**FILE NUMBER:** Z190-158(RM) **DATE FILED:** December 6, 2019**LOCATION:** Northeast corner of Gulden Lane and Singleton Boulevard**COUNCIL DISTRICT:** 6 **MAPSCO:** 44 Q**SIZE OF REQUEST:** ± 3.76 acres **CENSUS TRACT:** 101.02

**REPRESENTATIVE:** Laura Hoffman & Tommy Mann, Winstead PC**APPLICANT/OWNER:** West Dallas Investments, L.P.**REQUEST:** An application for a Planned Development District for office and mixed uses on property zoned an IR Industrial Research District.**SUMMARY:** The applicant proposes to develop the site with a special office project and mixed uses. The applicant requests to create a Planned Development District to increase the maximum height; define and create allowance of a community memorial plaza; removal of the residential proximity slope on Tract 1; and deviate from the streetscape, landscape, and sign regulations.**CPC RECOMMENDATION:** Denial without prejudice.**STAFF RECOMMENDATION:** Approval, subject to a revised development plan, a revised streetscape exhibit, and staff's recommended conditions.

## APPLICANT'S PROPOSED DEVELOPMENT PLAN (ENLARGED)

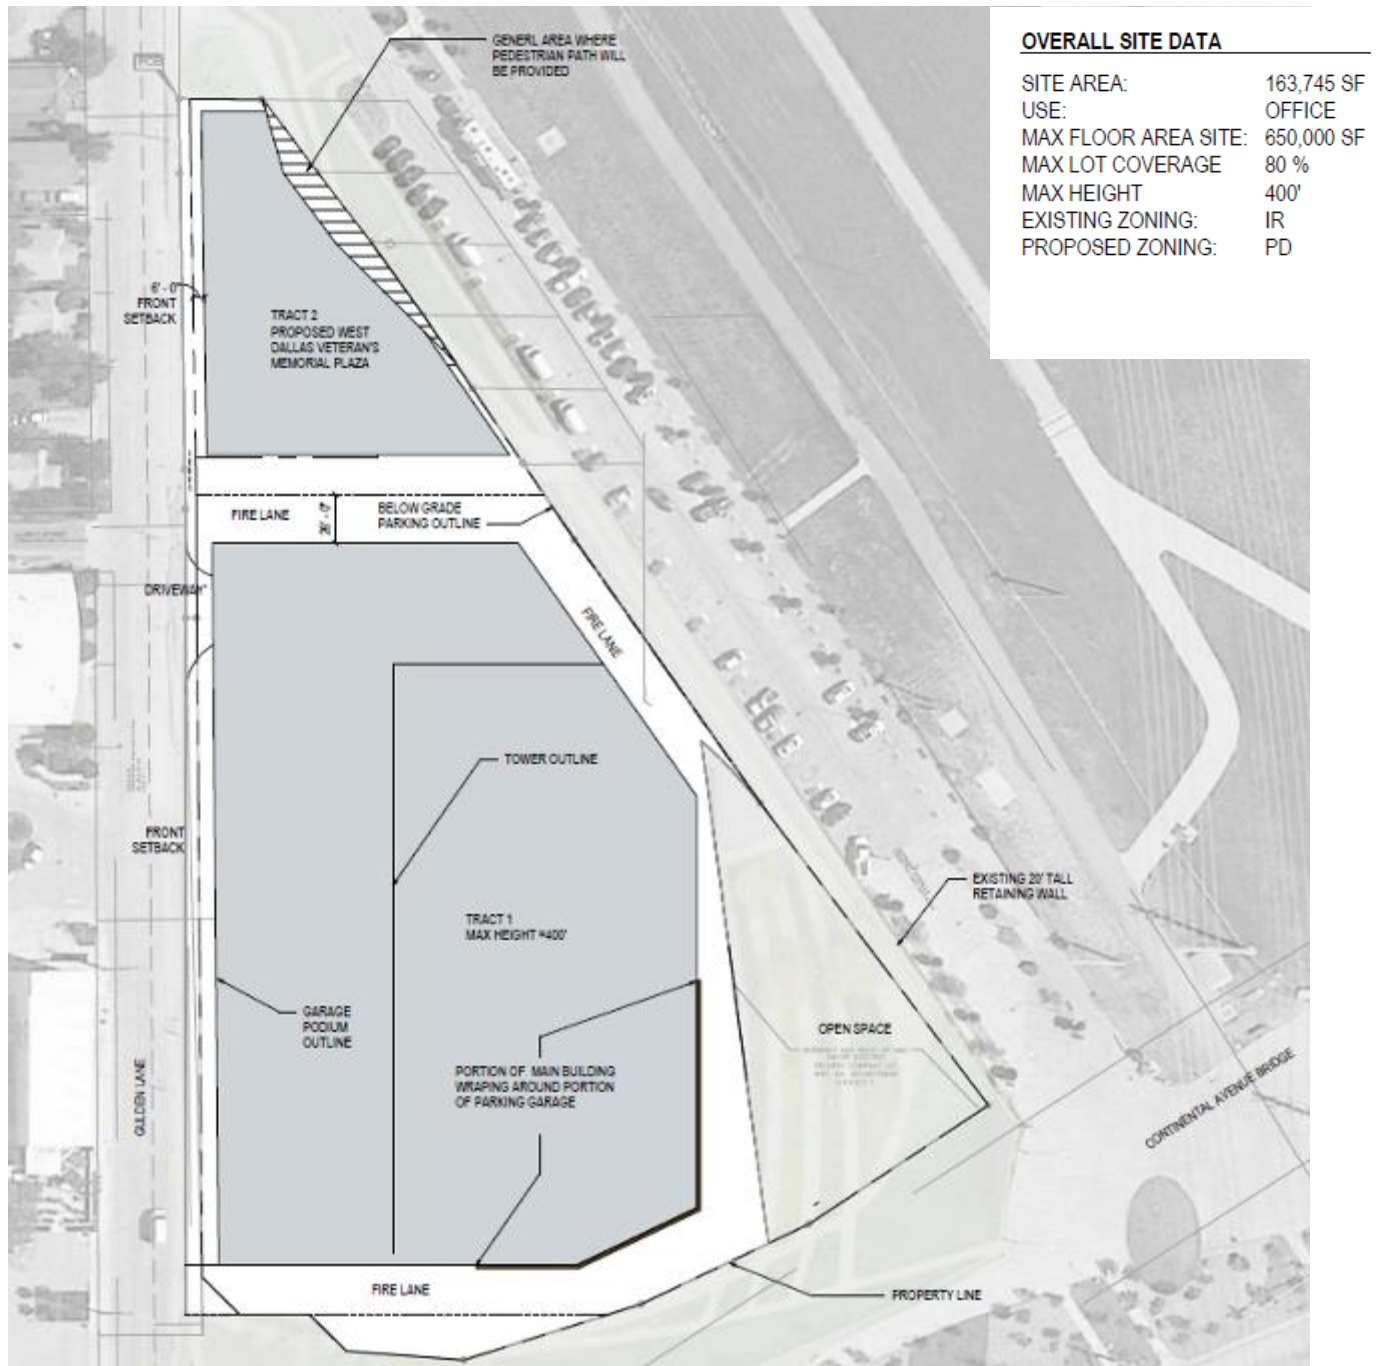
- 10) Allow shared improvements between Tract 1 and Tract 2 consisting of driveways, paved areas, fire lanes, and similar horizontal improvements.
- The proposed development plan has been revised to reflect a wider and longer pedestrian path, an open space area along the southeastern portion of the site, and the conditions have been revised removing the request for district identification signs and roof signs. The City Attorney Office, CAO has outlined concerns with roof tops signs, requested in PDs. As a result of the determination, rooftop signs are now limited to district identification signs, as an alternative. Staff does not support the inclusion of the open space due to the location along a major arterial road and the open space encroaching into a required 26-foot-wide fire land that encircles the development and prevents the open space from containing pedestrian amenities.

- As requested by the Commission, the development plan fails to provide an elevation for the office tower or garage podium and/or a varied height plan (like Z190-180) to better determine how the proposed height would be staggered with the maximum height moving east and away from the residential properties.
